Staff Report

Re: 1126 E Thistle Avenue Triplex – New Construction

Petition PLNHLC2021-00081

THISTLE AVENUE TRIPLEX – NEW CONSTRUCTION

A0.1

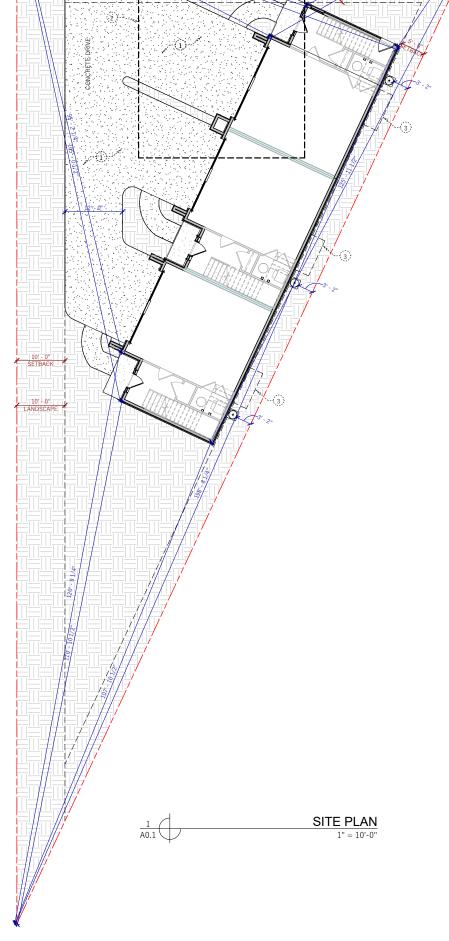
- 1. The landscaping plan shall be revised to create a distinct pedestrian entry from Thistle Avenue separate from the proposed driveway, and to break up the visual and physical impact of the concrete driveway with more landscaping, permeable pavers, or something similar.

The applicants have expressed a willingness to revise their landscaping to break up the visual impact of the concrete driveway with more landscaping, permeable pavers, or something similar. Staff will continue to work with the applicants on this and other details.

ZONING REVIEW CORRECTION SHEET

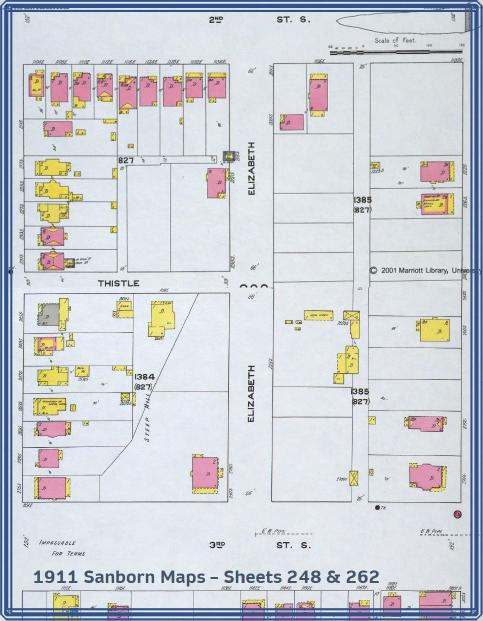
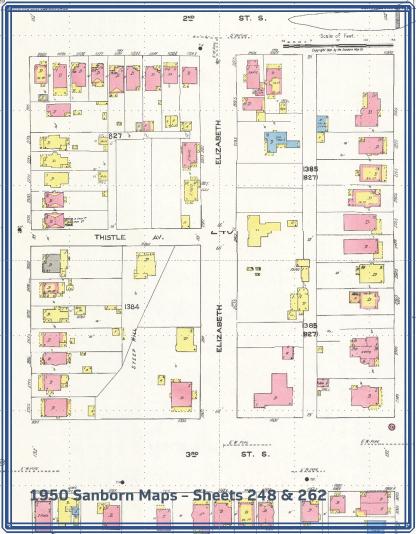
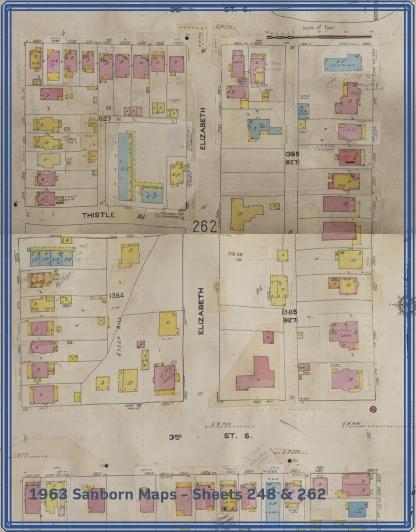
Those two conditions require a Planning Division petition be pursued, likely Special Exceptions per 21A.06.050.C.6.g. Petition to allow site layout as shown, and development of property without public street frontage, must be completed before building permit can be approved for zoning review.

2. Must obtain Certificate of Appropriateness from the Planning Division (due to project's location within a local historic district). Discuss that process with staff of Planning Division by reaching them at zoning@slcqov.com.

- 3. On site plan, depict alley and its width. Show roof plan on site plan and show all projections from building (balconies, canopies, etc.). Note property line lengths with accurate information (that matches legal description). And, tell lot square footage and the coverage of lot by building(s)- not to exceed 60% for multifamily.

- 5. Project is located in special study area. Provide Site Specific Seismic Hazard Report; upload to Soils, SWPP, and Drainage Reports folder.
- 6. Parking calculations are needed- tell the minimum required parking for current SFD use. Then, also tell the parking required for proposed use. Refer to parking requirements of 21A.44.030.G.1 table for minimum on-site parking requirements. Provide parking calculations on site plan, project information or cover sheet.

- 7. Provide landscaping plan for site. Minimum required landscaping is per 21A.48.090.
 - Show plantings grouped together per hydrozones, with irrigation for those groupings, to be per 21A.48.055.

- 8. Propose required recycling collection station, on site plan; to be per 21A.36.250.D and 21A.36.250.I, with screening per 2A.36.250.J.
- Access to proposed development appears to be via a private alley. Verify ownership of alley and if private, arrange cross access and shared maintenance agreements with all involved parties. Upload recorded versions of agreements to City Required Forms folder.

- 12. Show on site plan any ground mounted utility boxes involved with project, to be per 21A.40.160.
